PLANNING DIVISION STAFF REPORT

Project Address: 5404 Lake Mendota Drive (19th Aldermanic District, Alder Clear)

Application Type: Demolition and Conditional Use

Prepared By: Heather Stouder, AICP, Planning Division

Figure 1 – Nearby Lakefront Homes by Total Square Footage

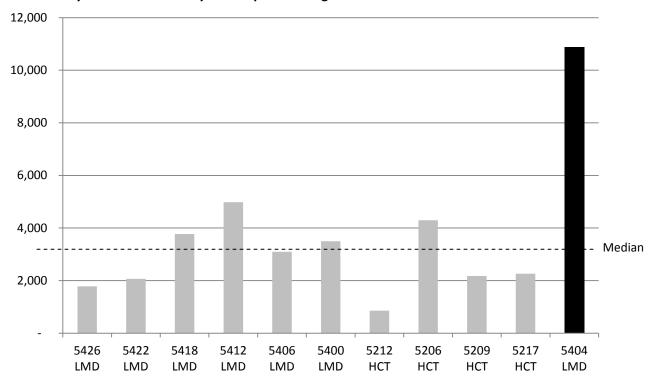
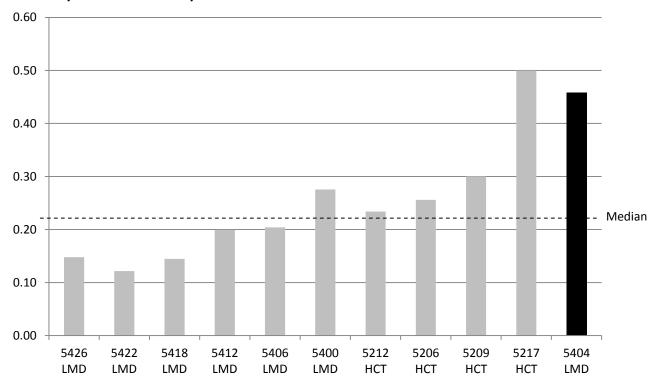
As shown in Table 1 and Figures 1 and 2, staff cautions that the proposed home as revised is well over three times larger than the median size of the five homes on either side of this property. Even when compared to two large homes constructed in the last decade along this stretch of Lake Mendota Drive, which are both approximately 4,300 square feet in size, the proposed home is over two times as large. While the subject property itself is comparatively large, the floor area ratio (FAR) for the proposed home, excluding the detached garage is 0.46, while the median FAR for are lakefront properties is 0.21.
